## Product Change Notification

PRECISION POTENTIOMETERS

May 24, 2012 -  
REVISED JANUARY 23, 2013

### Bourns Sensors & Controls Product Line - Model 6639 Product Enhancements

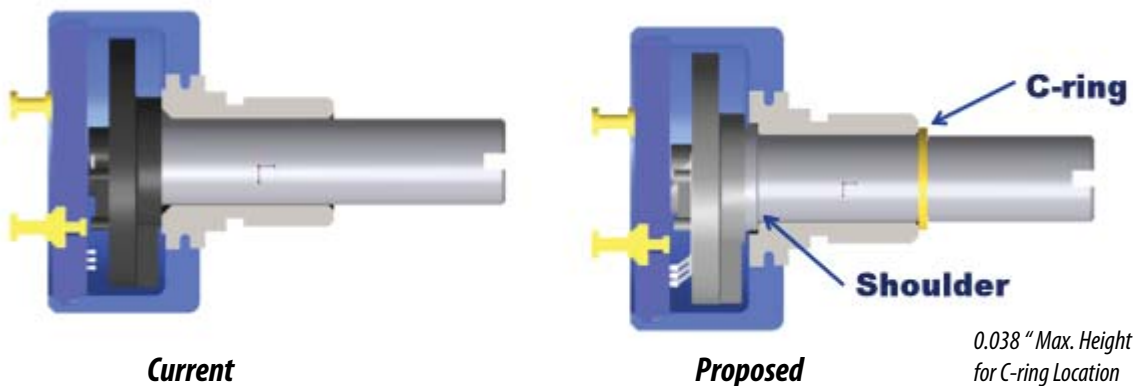
The design enhancements include the addition of a C-ring to help prevent damage that may be induced by excessive axial force applied to the shaft when installing gears or other mechanical devices, and the addition of an internal shoulder to the shaft to better resist shaft pull out from the body if excessive shaft pull force is applied.

Please refer to the shaft/bushing design illustrations below:

Externally, the design enhancements will be recognized by the C-ring that is visible in front of the bushing. The noted enhancements to this product family will have no effect on form or function. Both the new internal shoulder and five-point heat stake of the contact spring will help increase the robustness and reliability of the part. These design enhancements allow the potentiometer to withstand higher axial loads typically encountered on installation or removal of mechanical devices from the shaft. All performance specifications listed on the current data sheet will remain unchanged.
